Minutes – Standing Policy Committee on Property and Development – January 13, 2026

Item No. 15 Zoning Agreement Amendment – 1976, 1978, 1980, 1982, 1984, 1986, 1988, 1992, 1994, and 1996 St. Mary's Road (St. Norbert - Seine River Ward) File ZAA 9/2025 [c/r DAV 229107/2025C]

Title: ZAA 9/2025 – 1988 St. Mary's Road

Issue: For consideration at a public hearing to amend a Zoning Agreement under File DASZ 6/2018 to permit a maximum building height of 45 feet.

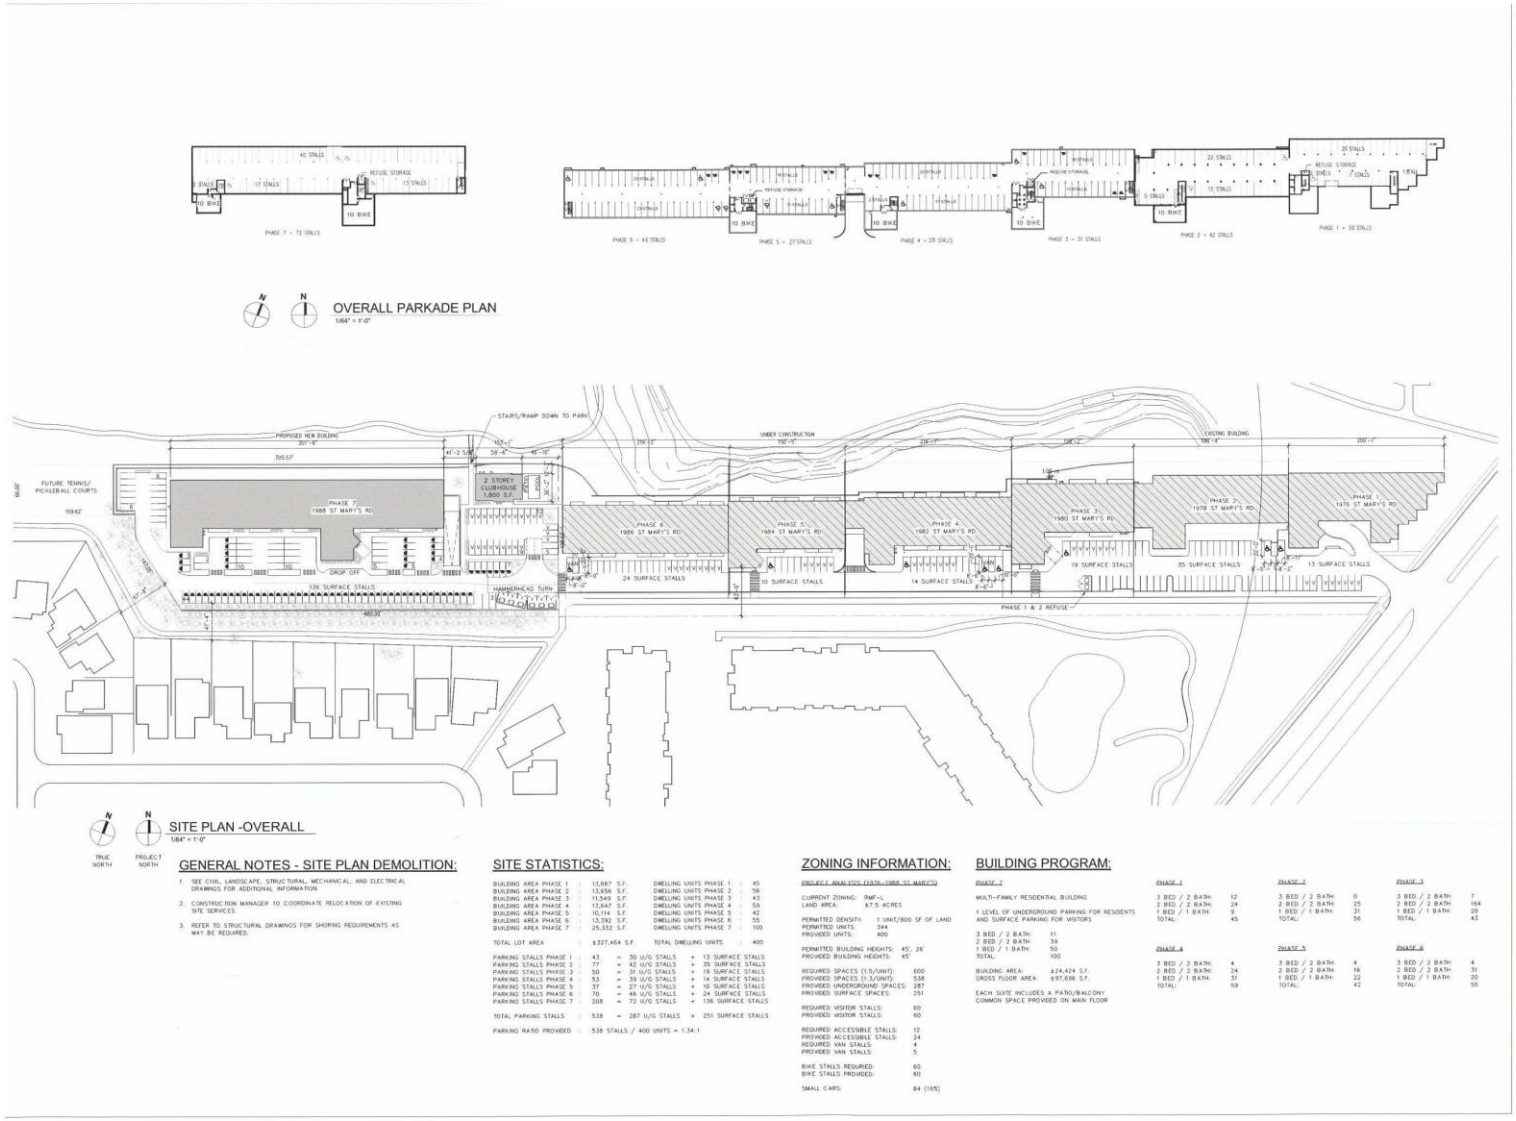
- Planning, the Riel Community Committee, the applicant, and the public were in agreement that a lower building height was necessary to achieve a context sensitive design for this site in 2018. No adequate rationale has been provided in the letter of intent to explain why the changes in the subject application have been requested. Further, the surrounding context of single-family homes to the south has seen no demonstrable changes that would result in a new context for the subject site.

- The Parks Division of the Public Works Department has indicated concerns regarding the impact to trees at the south of the subject site on the "PR1" land, which act as a buffer. Additional concerns include the garbage placement adjacent to the public path, and that land drainage must be handled internally to the site and not directed toward any adjacent park lands.
